**TOWN OF FAIRFAX  
STAFF REPORT ADENDUM  
Department of Planning and Building Services**

**TO:** Fairfax Planning Commission  
**DATE:** March 16, 2023  
**FROM:** Linda Neal, Principal Planner  
**LOCATION:** 67 Tamalpais Road; Assessor's Parcel No. 001-123-03  
**ZONING:** RS-6 Single-family Residential Zone  
**PROJECT:** Construction of a single-family residence, accessory dwelling unit and attached garage.  
**ACTION:** Hill Area Residential Development Permit, Design Review Permit, Excavation Permit, Revocable Encroachment Permit, Tree Removal Permit and Retaining Wall Height Variance, Driveway Width Variance, Variance to Allow the Required Uncovered Parking in the Combined Side-yard Setback and Combined Front/Rear Setback Variance; Application # 22-29  
**APPLICANT:** Ron Kappe, Architect  
**OWNER:** Stephen Altman  
**CEQA STATUS:** Categorically exempt, § 15303(a)

**67 TAMALPAIS ROAD**

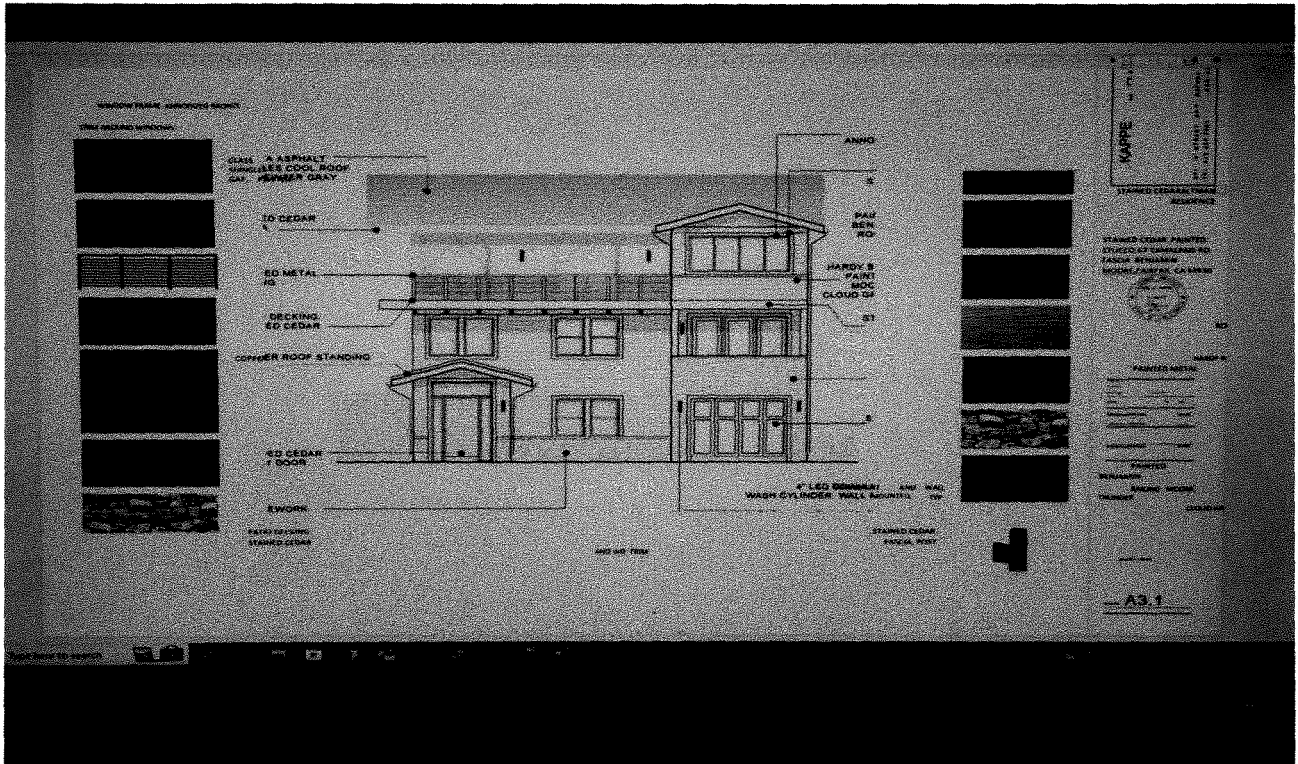
Only one window is proposed on the west side of the structure where it is closest to the ADU and residence at 73 Tamalpais Road. This window and the other numerous windows of various shapes and sizes proposed on the north, east and south sides of the structure will have anodized bronze framing.

The second-floor deck that originally ran the entire width of the building has been limited to the east side of the residence with the relocated dining room stacked on top of one of the bedrooms on the second floor and above the one car garage on the first floor. The design no longer includes any exterior stucco siding. The siding will be horizontal Hardy Board siding painted a light grey (Benjamin Moore, Thunder Cloud Gray, 2124-40) and portions of the front façade will have a stone façade similar in color and texture to the existing wall along the adjacent section of Tamalpais Road and the rear access stairway to 63 Tamalpais Road. The upper roof peak now runs east west and the roof pitch over the dining room and over the front entryway mirror the roof peak of the two story garage/ADU structure at 73 Tamalpais Road. The fascia, second floor porch support posts, roof trim, decking and front door will be stained cedar. The roof will be Class A asphalt shingles cool roof in light grey (pewter gray). Deck railings will be metal painted a bronze color to match the roof and window trim. A copper standing roof is proposed over the front entryway.
